Well Name	Well Number	US Well Number	Lease Number	Case Number	Operator
STEEL GUITAR	331H	3001555818	NMNM19609	NMNM19609	WPX ENERGY
STEEL GUITAR	332H	3001555819	NMNM19609	NMNM19609	WPX ENERGY
STEEL GUITAR	323H		NMNM19609	NMNM19609	WPX ENERGY

Sundry ID: 2856743

Type of Action: APD Change

Procedure Description: WPX Energy Permian, LLC (aka Devon Energy Production Co., LP) respectfully requests a drill plan change for the subject wells (331H API ID 1400098053, 332H API ID 1400098054, 323H API ID 1400098051). WPX also requests break test and offline cementing variances. Please see revised drill plan for the deepest TVD well on this pad and variance attachments.

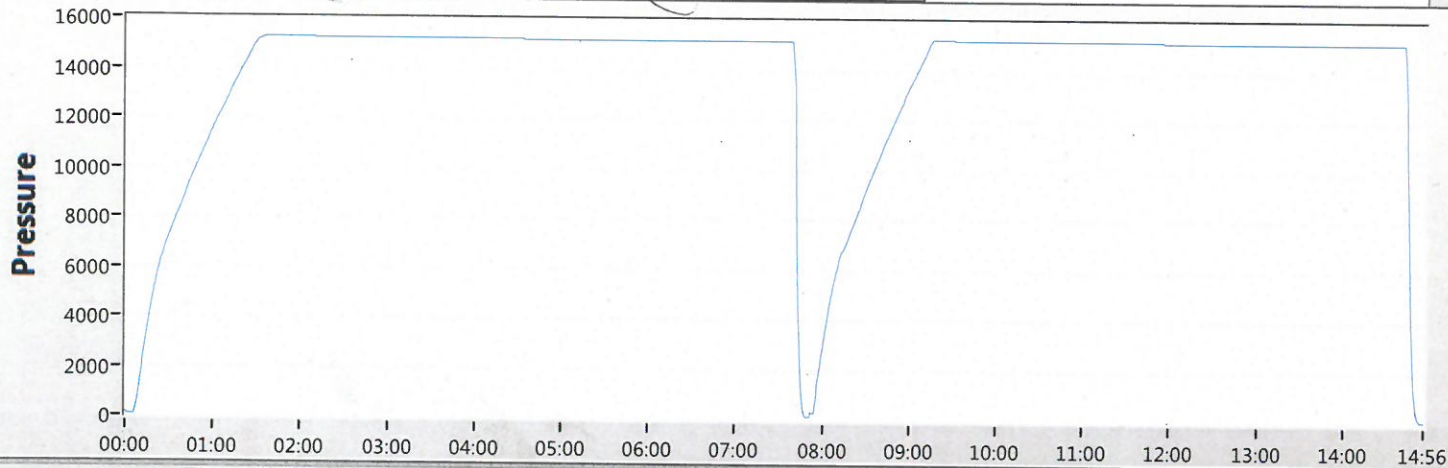
Devon requests offline BOPE testing for the following components: Upper Rams, Blind Rams, Kill Valves, Choke Valves, and Annular

Remaining well control equipment components will either be tested offline or online, per BLM approval

Remaining BOPE will be tested online within 72-hours from completing the offline BOPE component testing

Notify the BLM if the online BOPE testing exceeds 72-hours

All Full Tests not completed "Offline" or "Offline, BOPE" are required to be complete Online

Devon requests Break testing as stated above for 5K tests, not including production hole

Annular Preventer will be tested to minimum of 70% RWP and higher than MASP during initial BOP test

Pressure testing is required for pressure-containing connections if the integrity of a pressure seal is broken during a break test

Full Tests required when entering production hole

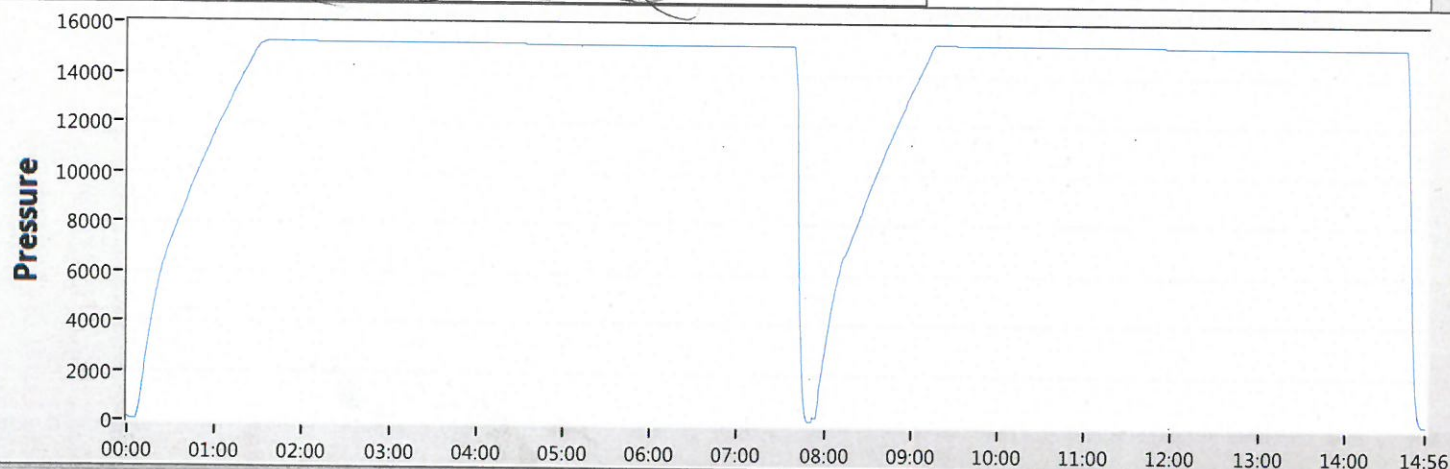
Annular Preventer will be tested to minimum of 70% RWP and higher than MASP during initial BOP test

Pressure testing is required for pressure-containing connections if the integrity of a pressure seal is broken during a break test

Full Tests required when entering production hole
